PECAN-YOUNG SUBDIVISION

APPLICATION NUMBER 31 DATE January 8, 2004

REQUEST Subdivision

PECAN-YOUNG SUBDIVISION

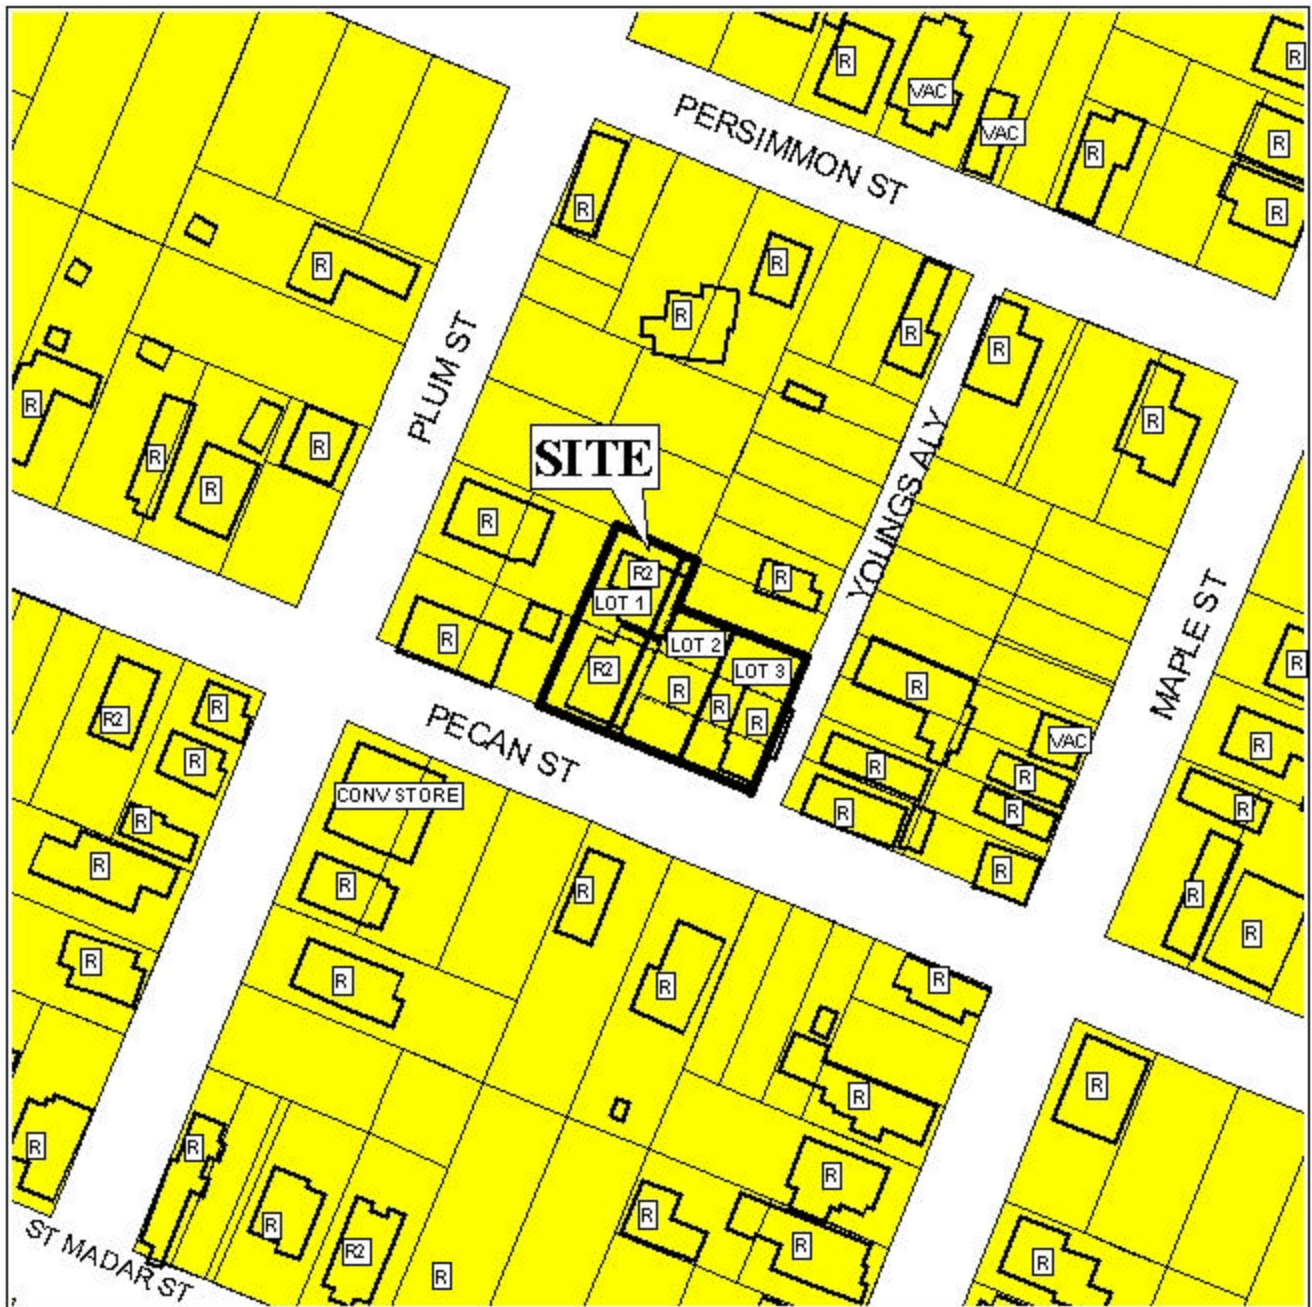
Young Street, which has an existing right-of-way of 20-feet, is a minor street, and as such requires a 50-foot right-of-way; therefore, the dedication of sufficient right-of-way to provide 25 feet from the centerline should be required. In addition, a 25' radius would be required at the intersection of Young Street and Pecan Street.

There are a few concerns with the proposed application. The first deals with the substandard right-of-way along Young Street. With the dedication of 15' of right-of-way, Lot 3 would be only 30' wide, exclusive of the required setback, reducing the buildable width to 20-feet. In addition, a 25' radius would also be required for at the corner of Pecan Street and Youngs Alley.

The second concern deals with the proposed lot sizes. The applicant is proposing lots ranging in size from 3,600 to 4,675 square feet and in lot width from 42.5' to 45' wide. Section V.D.2. of the Subdivision Regulations requires a minimum of 7,200 square feet and all residential lots shall have a minimum width of 60'.

The third concern relates to the requested setbacks. The applicant is proposing a front yard setback of 15' along Pecan Street; the Zoning Ordinance requires a front yard setback of 25-feet along Pecan Street.

The fourth concern deals with possible Zoning Ordinance violations. As illustrated on the Vicinity Map, there are several structures that would cross the proposed property lines. These structures would have to be removed or a minimum setback should be provided.

Based upon the preceding, this application is recommended for denial for the following reasons: 1) the proposed lots do not meet the 7,200 square foot minimum lot size requirement and do not provide minimum width of 60' (Section V.D.2.); 2) the requested front setback does not meet the minimum 25' front setback for new lots as stated in Section V.D.9.; and 3) the existing structures would create a Zoning Violation.
